## PRODUCT CHANGE NOTIFICATION

#PCN-DCT-3CW6-10

Business Unit	Product Line Code	Type of Change	Action	Date of issue
DCT	205	Aesthetic	Notify Distributors and Field	07/07/2010

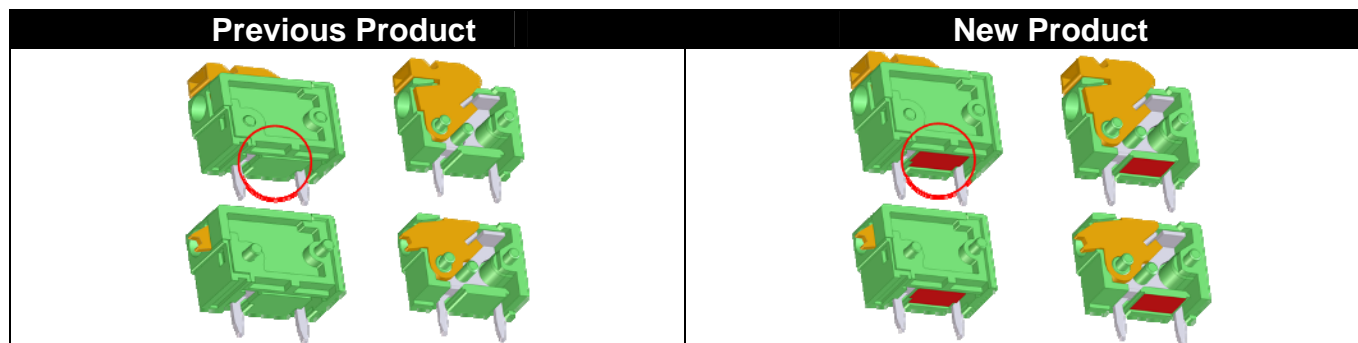
To improve the following FKDS terminal block products, they will now be made with a recess on the bottom of the block. In addition the wall will become thinner between the solder pins. All dimensions and technical data will remain the same.
